# The Goodyear Tire & Rubber Company

This refers to our application dated July 25, 1979, for renewal of License Number 34-00508-06. Reference Mail Control Number 95025. The additional information you requested is provided below.

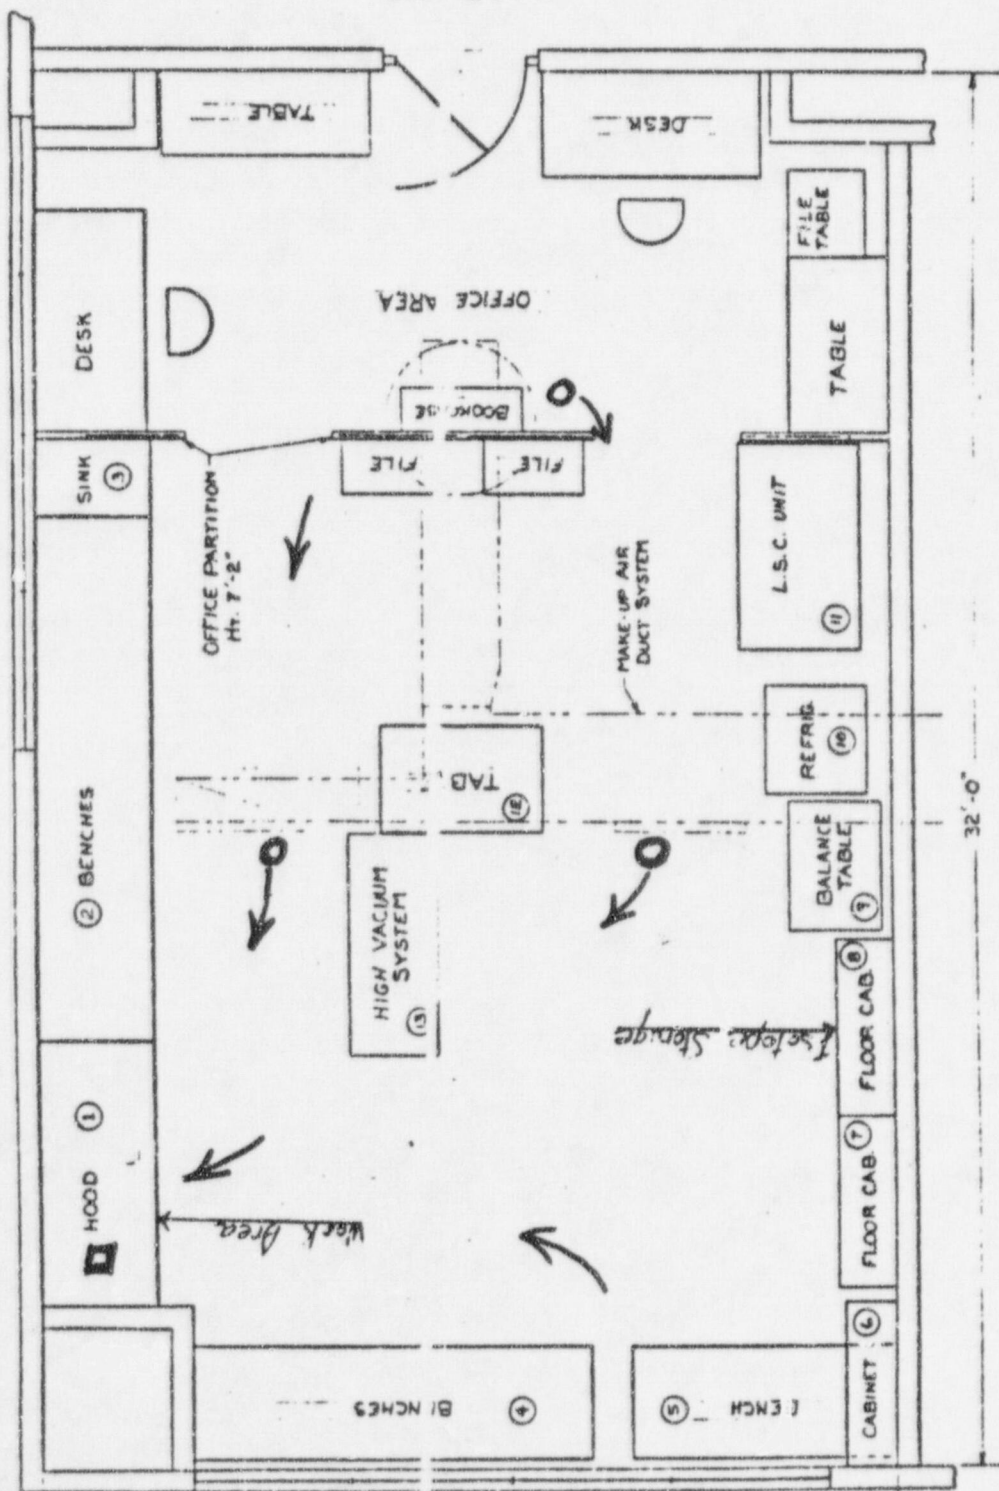
1. Facilities and Equipment: Enclosed, is a sketch of the laboratory where byproduct materials are used and stored.
2. Control of Effluent Releases: We have determined that monitoring is not required for the following reasons:

Areas surveyed in the isotope laboratory (diagram - item I) include: (1) exhaust hood; (2) south bench tops; (3) sink; (4-5) east bench tops; (8) isotope storage cabinet; (9) balance table; and (12) work table. Floor space immediately surrounding or in front of the above areas is included in the survey. In the office area of the laboratory, desk tops are surveyed for the presence of contamination. Non-routine surveys are conducted usually prior to, and upon completion of, experimental work with isotopes in the area of principal use (exhaust hood).
